REV.	DESCRIPTION	DATE	BY
1	SCHEMATIC	5/1-2/23	D

PART NO. 511-2123
 DATE 5/1-2/23
 BY D

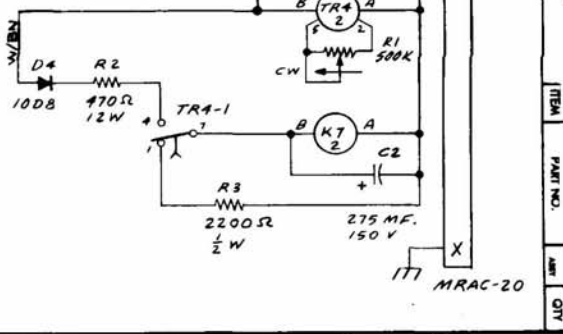
REV.	DESCRIPTION	DATE	BY
D	REVISED PER DCN 1868	5-1-81	DCM
C	ADDED JUMPER PER DCN #1801	4-2-81	DCM
B	ADDED CONNECTION TO PUMP V. OBLITERATED K4-B. QUANTITAZ	DIAZ 2-4-81	DCM
A	ADDED WIRE TO PUMP PER DCN 1699	11-15-80	DCM

NOTE:
 1) ADD JUMPER ACROSS K6-3 N.O. CONTACT FOR D.P. SYSTEMS (#0511-2123-1) ONLY.
